ADDENDUM NO. 5
HWEA CONTRACT # 133-2019-01
HAMMOND-WOOD WASTEWATER TREATMENT PLANT EXPANSION
HOPKINSVILLE WATER ENVIRONMENT AUTHORITY
HOPKINSVILLE, KENTUCKY
WAUFORD PROJECT NO. 1983

Date of Addendum: Friday, January 24, 2020
Bid Opening: Thursday, February 6, 2020, 2:00 p.m. Central Time

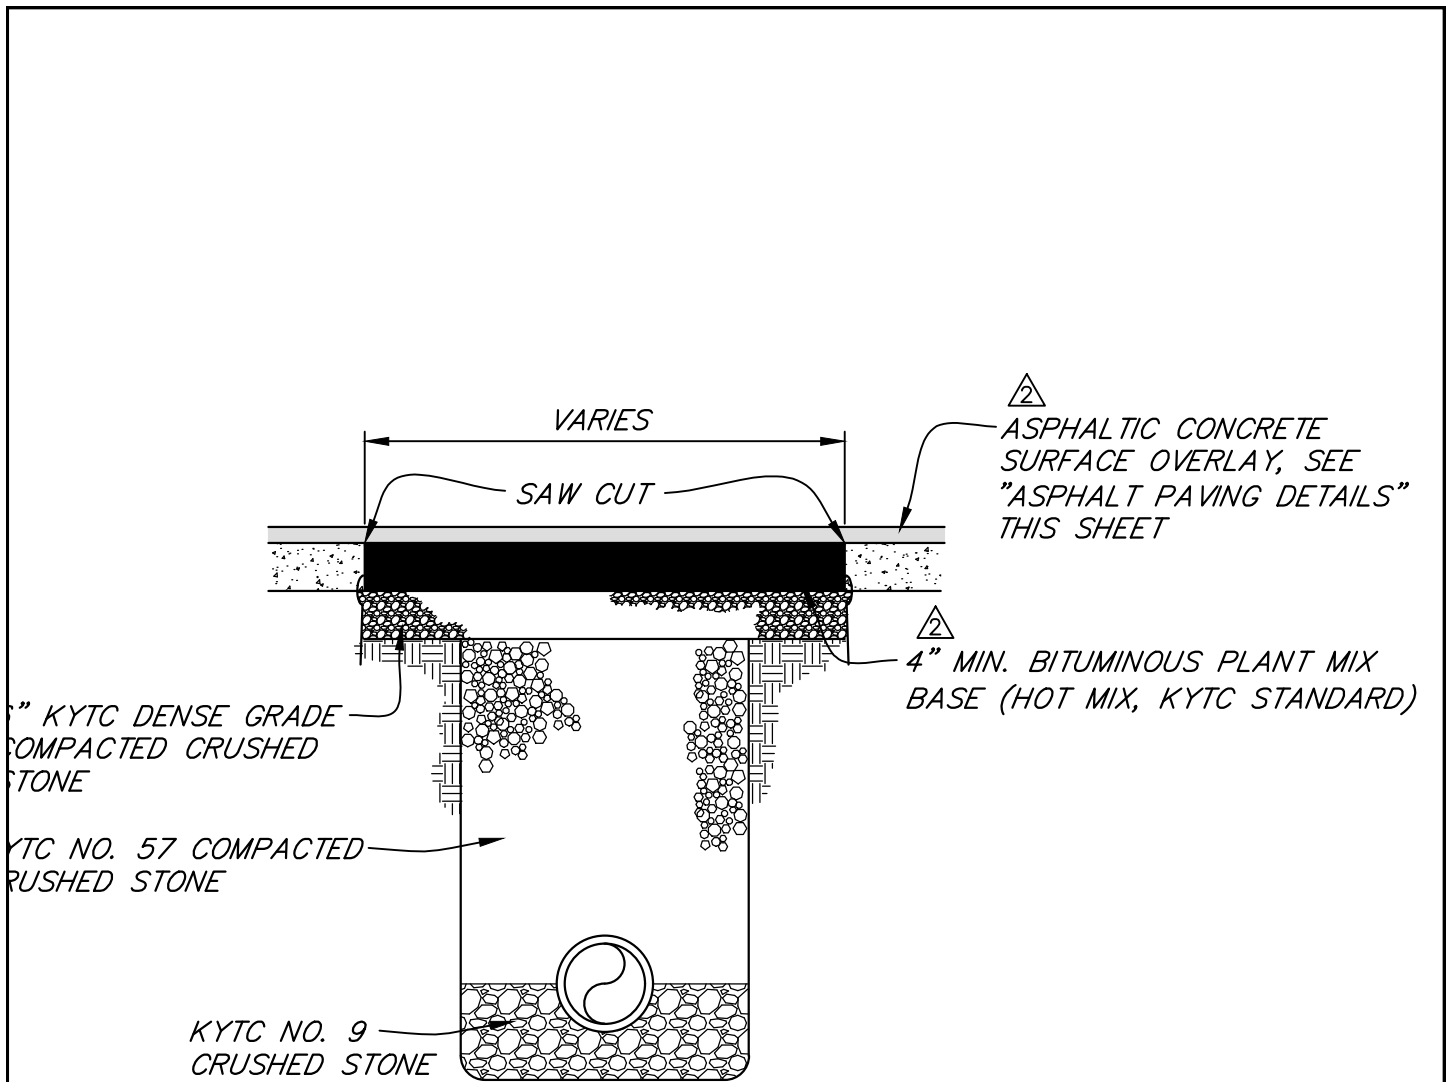
21. Plans, Sheet 25:

Modify as shown on the attached 8 ½” x 11” sheet.

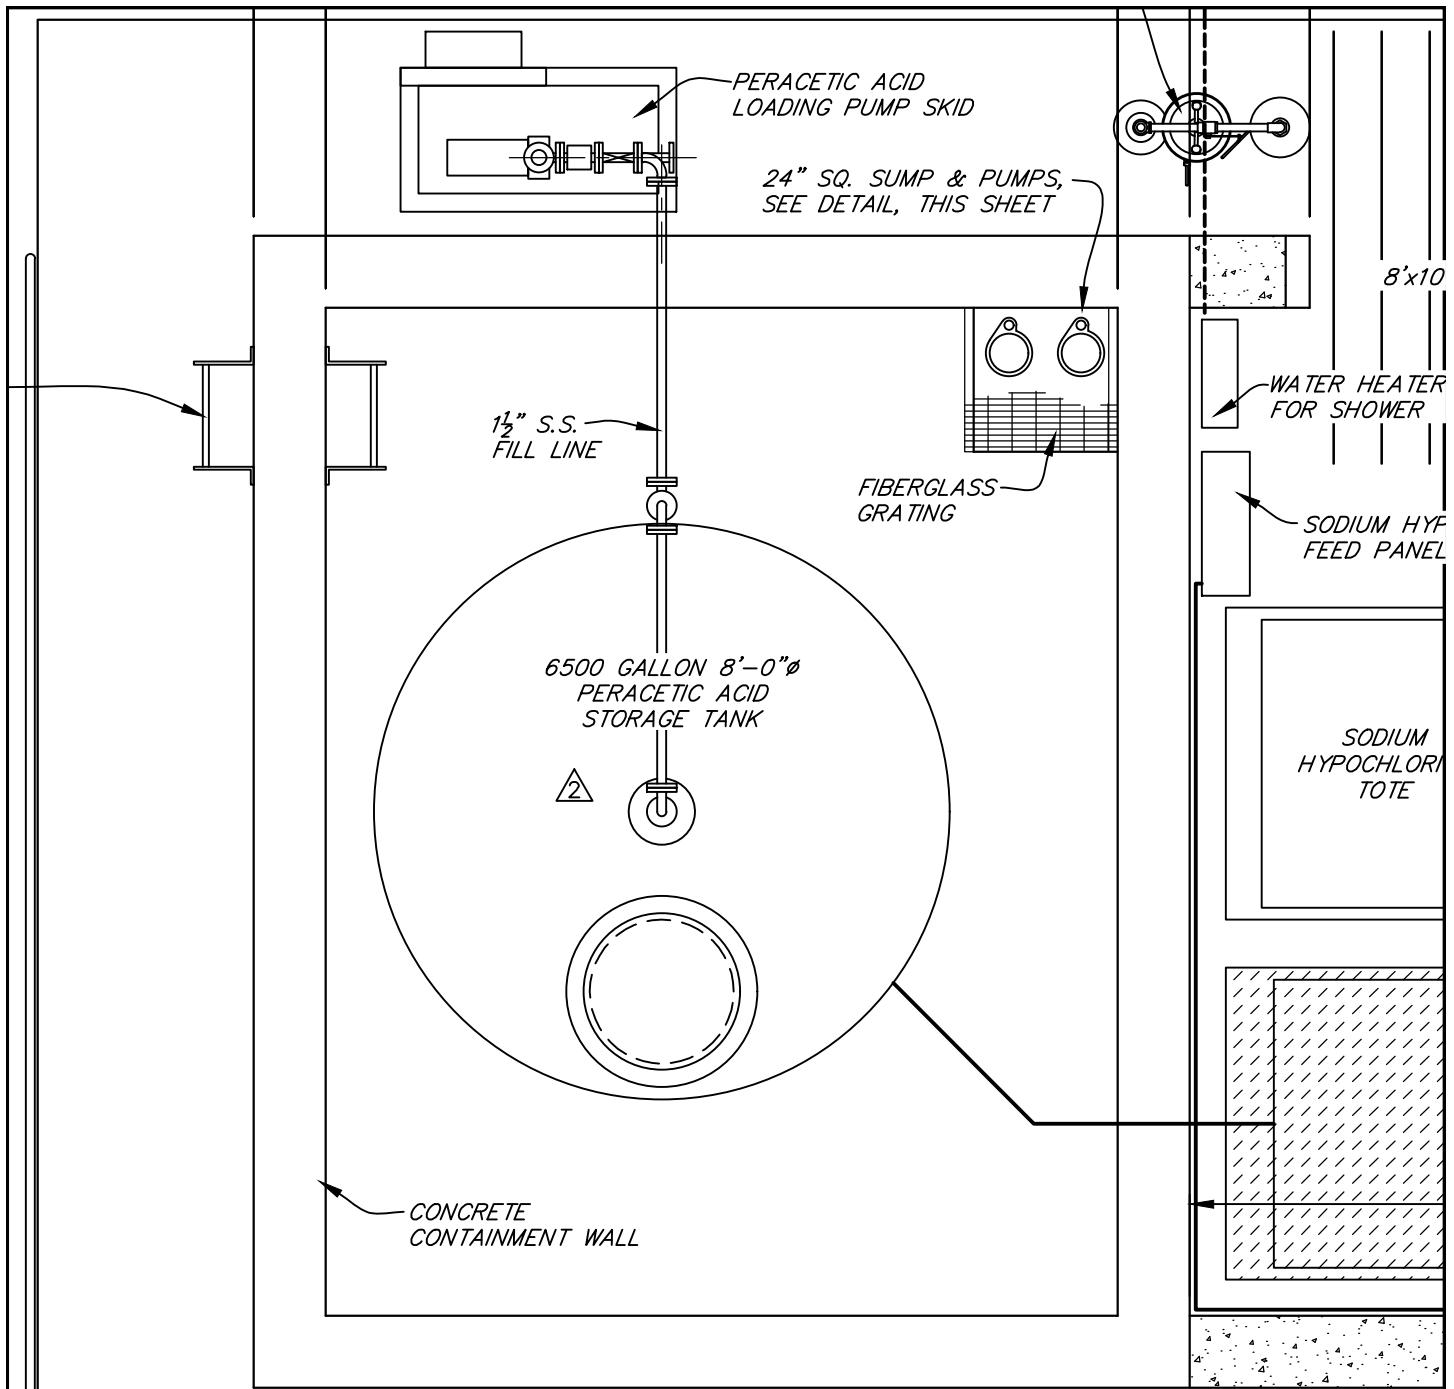
22. Plans, Sheet 74:

Modify as shown on the attached 8 ½” x 11” sheet.

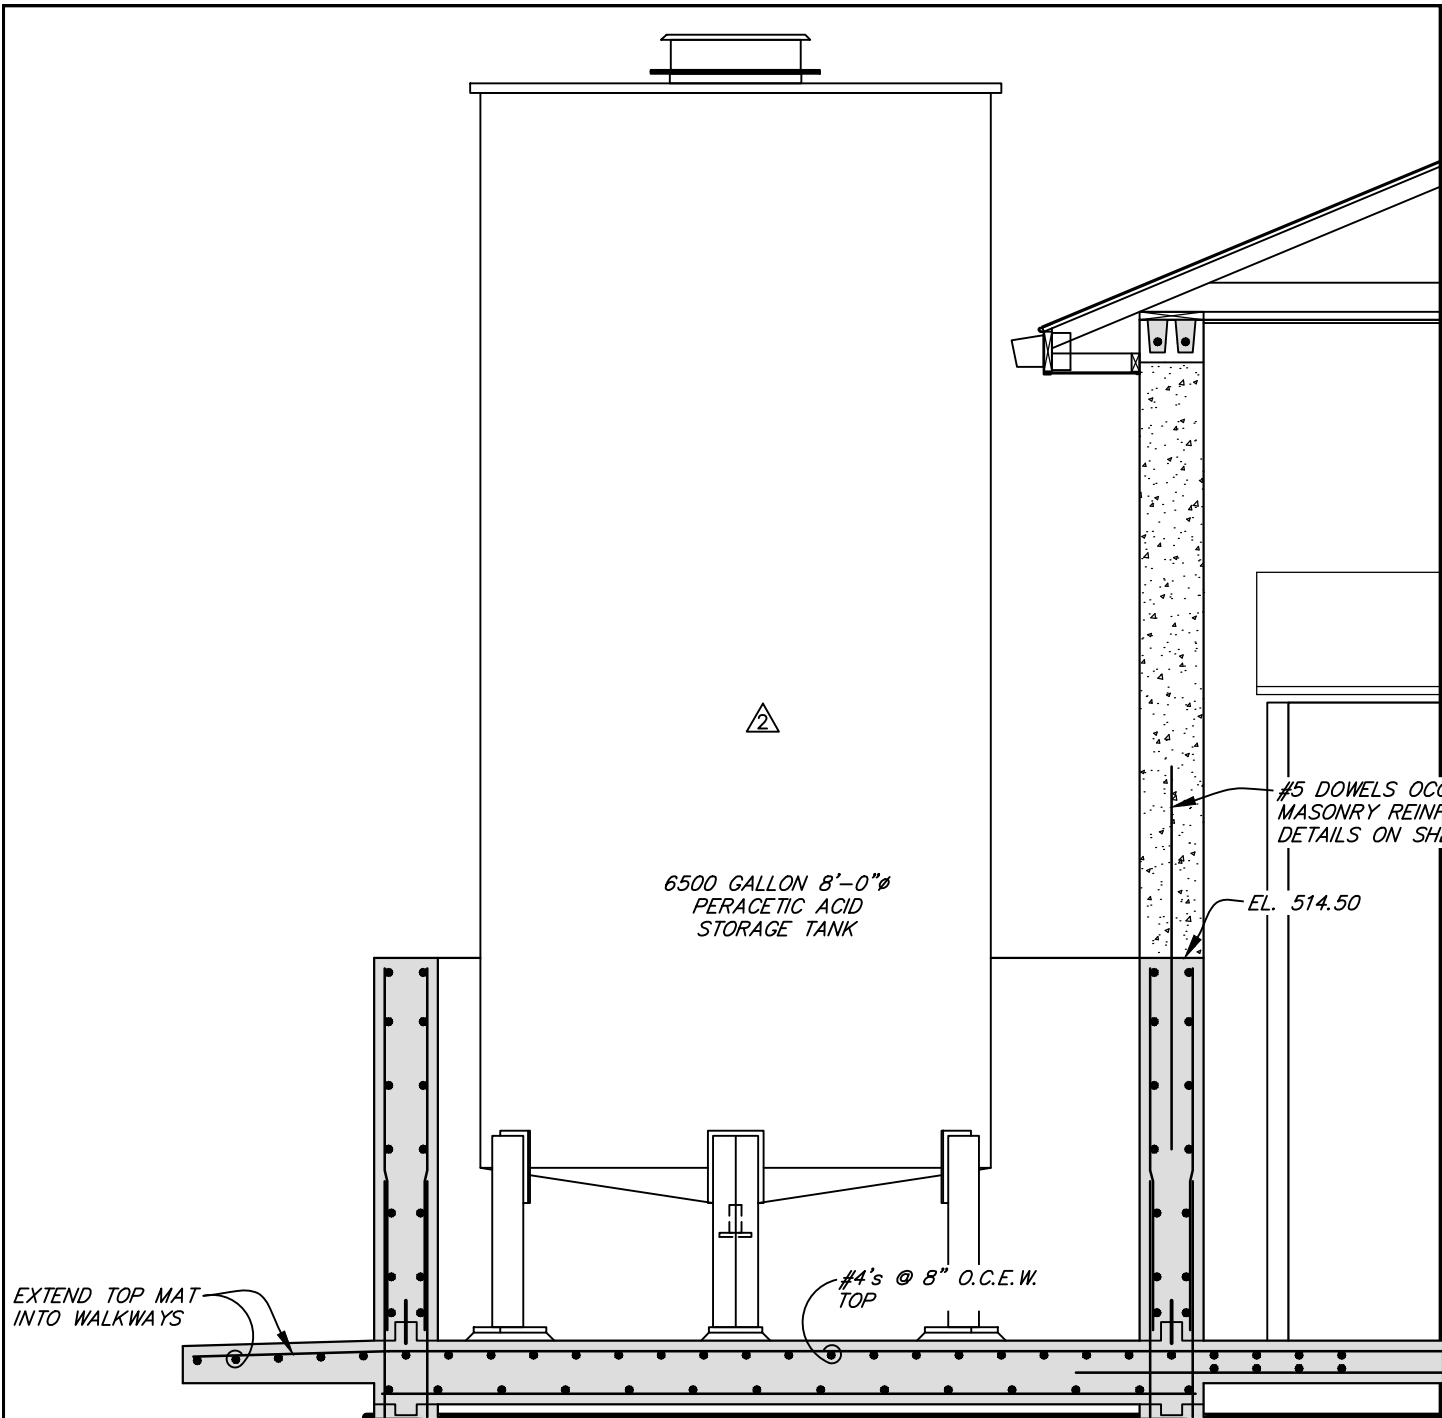
23. Plans, Sheet 75:

Modify as shown on the attached 8 ½” x 11” sheet.
